Product / Process Change Notification (PCN)

PCN Number: PCN_IndLHMD_20240729 Affected Series: WE-LHMD Affected Order Codes: 74434301XXXXXX PCN Date: 2024-04-29 (YYYY-MM-DD) Effective Date: 2024-07-29 (YYYY-MM-DD)		Change Category: ☐ Equipment/Location ☒ General Data ☐ Material ☒ Process ☒ Product Design ☐ Shipping/Packaging ☐ Supplier ☐ Software						
Contact: Product Management Phone: +49 (0) 7942 - 945 5001 Fax: +49 (0) 7942 - 945 5179 E-Mail: pcn.eisos@we-online.com		Datasheet Change: ☒ Yes ☐ No Attachment: ☐ Yes ☒ No						
Description of Change: With the aim of an extended product applicability, Würth Elektronik eiSos will change the marking method by including the winding start point. The new revision of the affected order codes will be sent out after the previous revision is out of stock (according to FIFO - first-in, first-out). There will be no change in fit, function, quality, or reliability of the product.								
Details of Change: For the following WE-LHMD 74434301XXXXXX will update the datasheet by indicating the start of winding point in the product marking representation and the schematic. Besides, Würth Elektronik eiSos advises the winding towards as clockwise in t

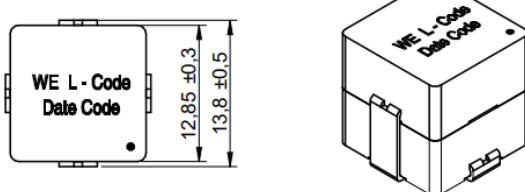
Marking:	For the size 1008. 	For the size 1008. 
	For the size 1213. 	For the size 1213.  With L-Code as the Inductance Code, and Date Code as YYWW, where YY is the year and WW is the week number according to the ISO-8601 standard.
General Properties:	No reference to start of winding.	Start of Winding: Winding towards clockwise.
